Work Order ID 150716

Item ID: 646.3312**REV N / C 3****Accept*****N900040100*****Setup Start*****NS1*****Revision ID:****Stop*****NS2*****Item Name:** Center Plate**Start Date:** 8/8/2016 **Start Qty:** 4.00***4*****Cust Item ID:****Required Date:** 8/29/2016 **Req'd Qty:** 4.00***4*****Customer:****Reference:****Approvals:****Process Plan:****DAS****21****9-09****Date:** AUG 30 2016 **Tooling:****Date:****Run Start*****NR1*****QC:****Date:****SPC (Y/N):****Date:****Stop*****NR2*****Sequence ID/
Work Center ID****Operation
Description****Set Up/
Run Hours****Tool ID****Tool #****Plan
Code****Accept
Qty****Reject
Qty****Reject
Number****Insp.
Stamp****Draw Nbr****Revision Nbr**

ENGINEERING CHANGE NOTICE NO.

DWG TITLE: UPPER CUTTER ASSY

SHEET 5 IS:

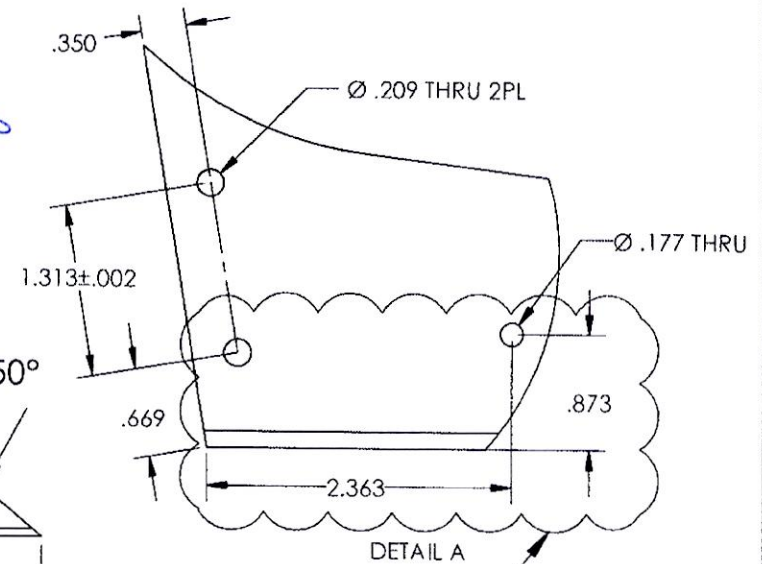
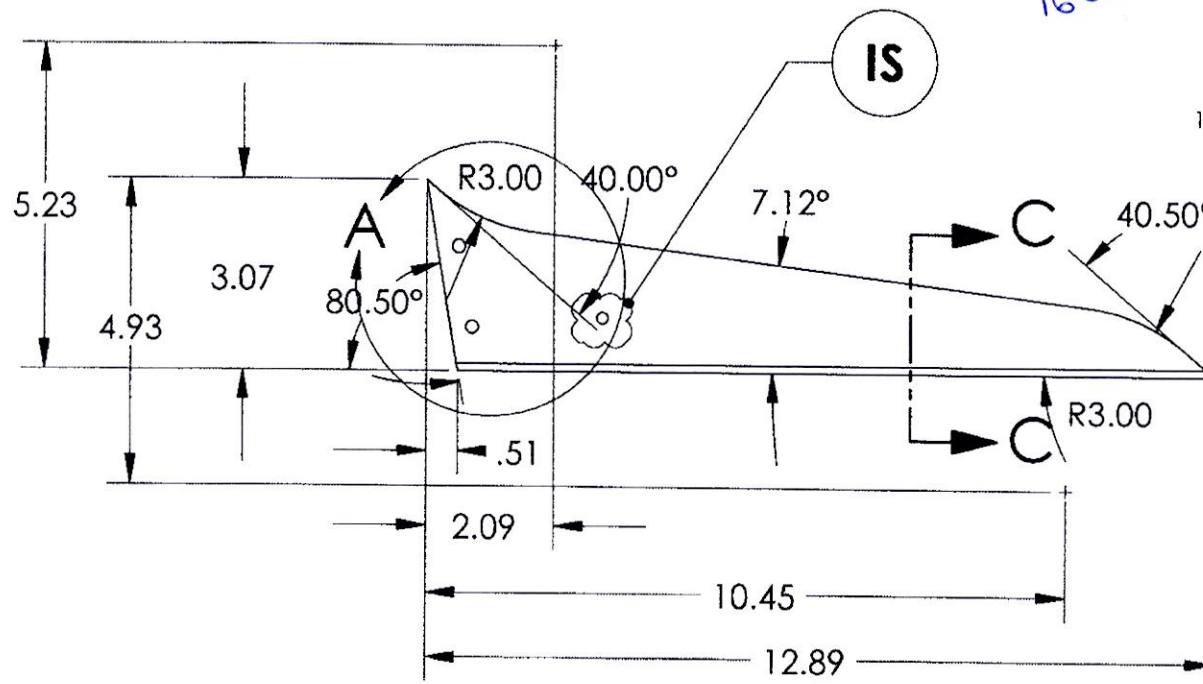
REASON: ADDED HOLE DIMENSION TO 646.3313.

SHEET 4, ZONE B8 IS:

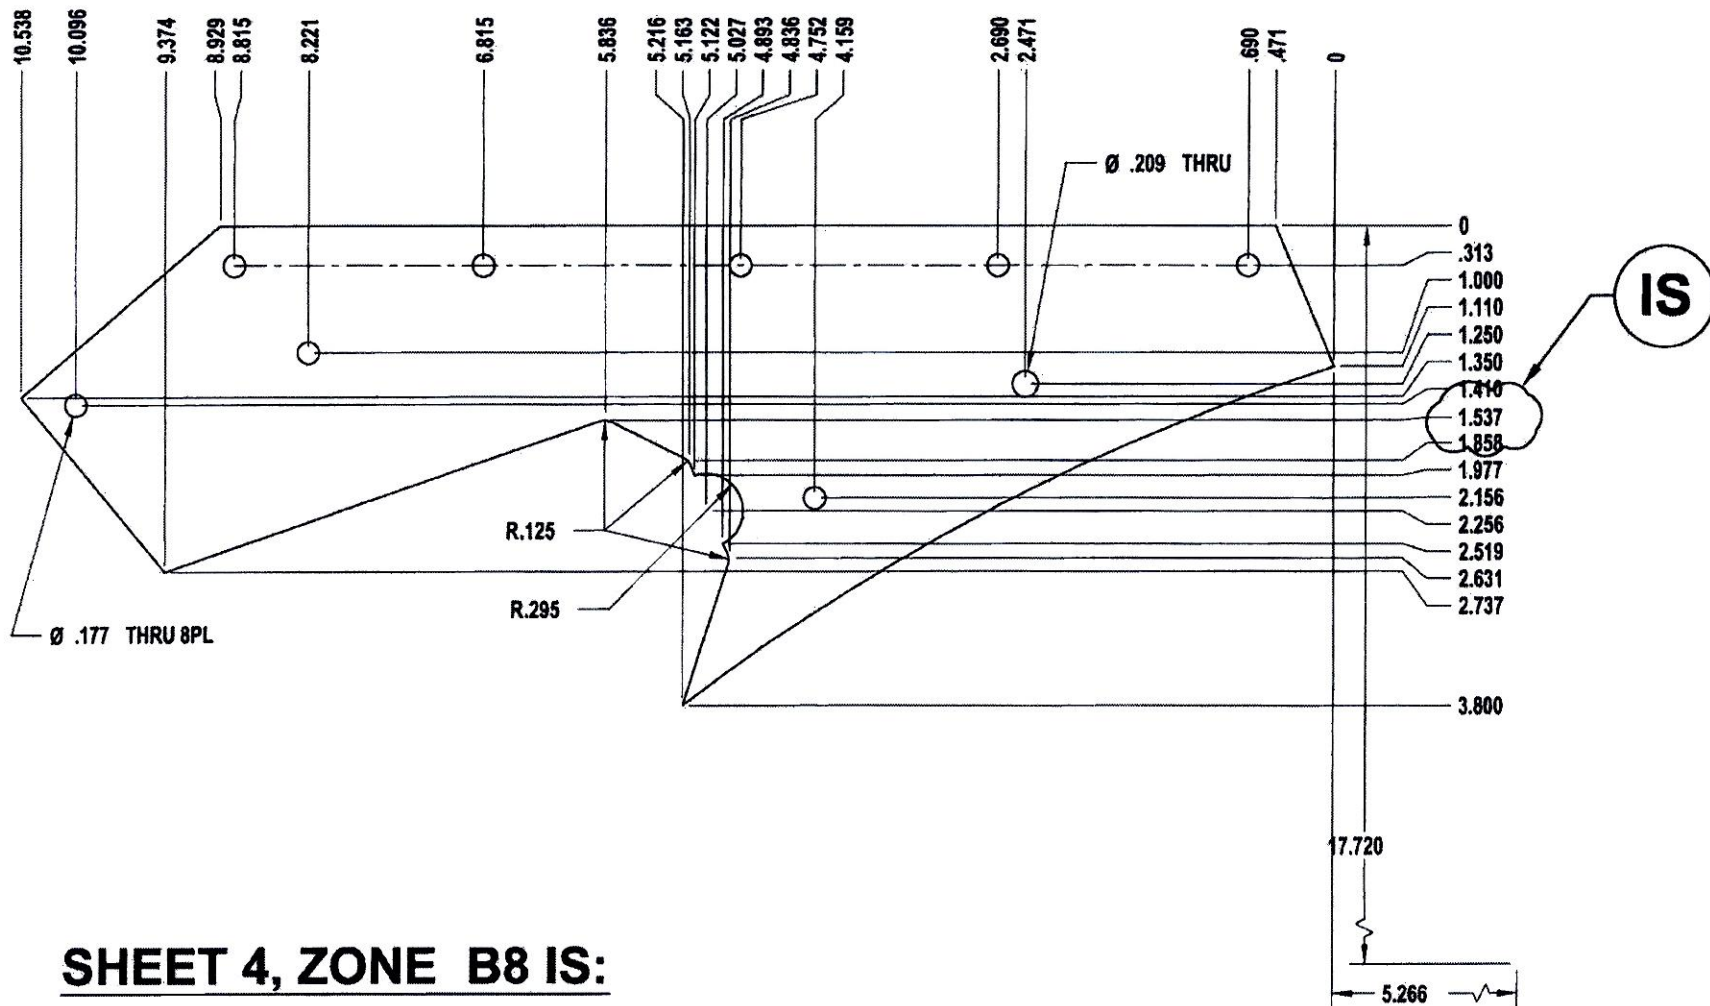
APICAL INDUSTRIES, INC.	ENGINEERING CHANGE NOTICE NO. 03724				SHEET 1 OF 1	
	DWG NO. 646.3300	REV: N/C	PREPARED BY: B. PETERS	DATE: 12/05/12	EFFECT ON DWG ☐ INC. ☒ UNINC.	
	DWG TITLE: UPPER CUTTER ASSY					
APPROVED BY: ENGR <i>[Signature]</i>		MFG <i>[Signature]</i>		QC <i>[Signature]</i>	EFFECT: NEXT ORDER	
TRANSACTION CODES (TC): A-ADD C-CREATE R-REVISE D-DELETE		REASON: REVISED ORDINATE DIMENSION.				ECR: D-12-025

SHEET 1, VIEW 646.3301, IS:

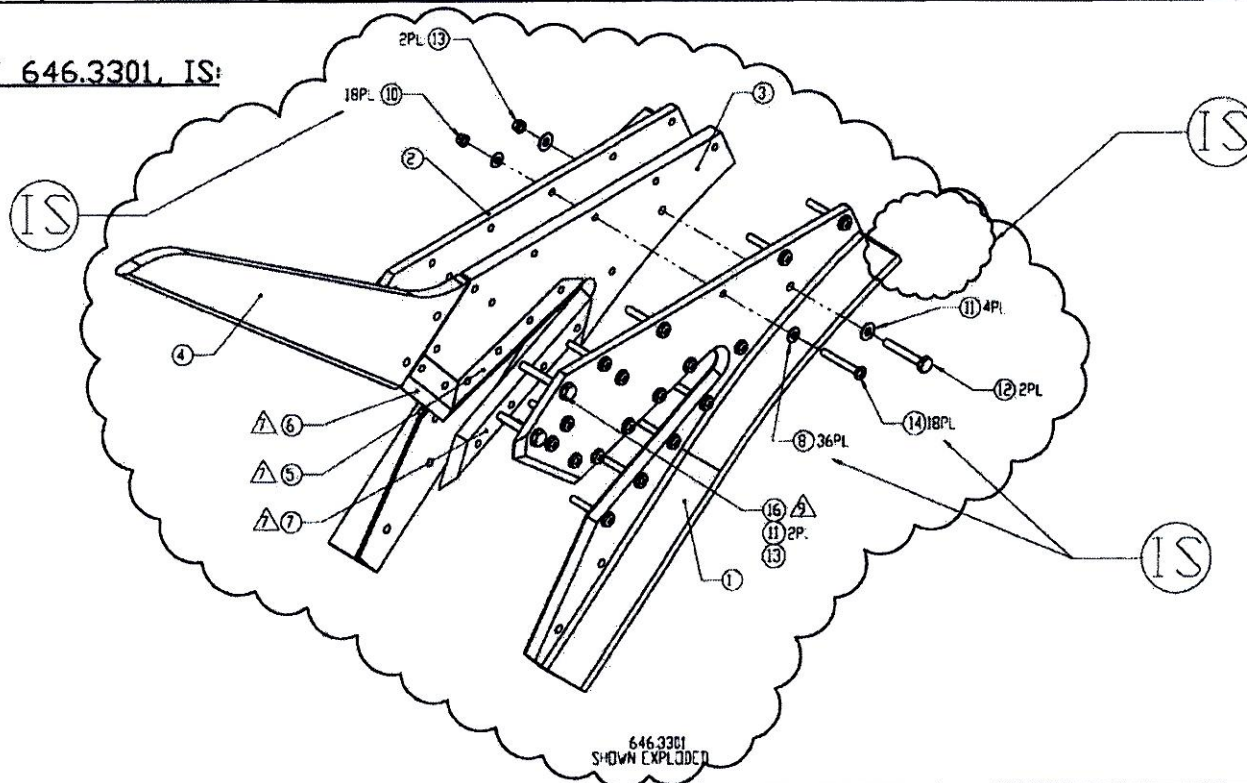
APICAL INDUSTRIES, INC.	ENGINEERING CHANGE NOTICE NO. 02196		SHEET 1 OF 2	
	DWG NO. 646.3300	REV: N/C	PREPARED BY S. HUFF	DATE: 01/05/09
	EFFECT ON DWG ☐ INC. ☒ UNINC.			
	DWG TITLE: UPPER CUTTER ASSY			
APPROVED BY: ENGR <i>[Signature]</i>		MFG <i>[Signature]</i>	QC <i>[Signature]</i>	EFF: NEXT ORDER
TRANSACTION CODES (TC) A-ADD C-CREATE R-REVISE D-DELETE		REASON: REMOVED RIVETS IN FAVOR OF ADDITIONAL SCREWS

14	R	601.2765	18	SCREW	MS27039-0819
10	R	601.1541	18	LOCKNUT	MS21042L08
9	D	601.2766	3	RIVET	MS20470AD5-18
8	R	601.2764	36	WASHER	NAS1149FN832P
			3301		
F/N	TC	PART NUMBER	QTY	DESCRIPTION	MATERIAL/SPECIFICATION
DOCUMENTS EFFECTED:				CHANGE CATEGORY	DER REVIEW REQUIRED
				☐ MDL ☒ INSTALL INSTRU ☒ ICA ☐ FMS ☒ BOM	☐ MAJOR ☒ MINOR
					☐ YES ☒ NO
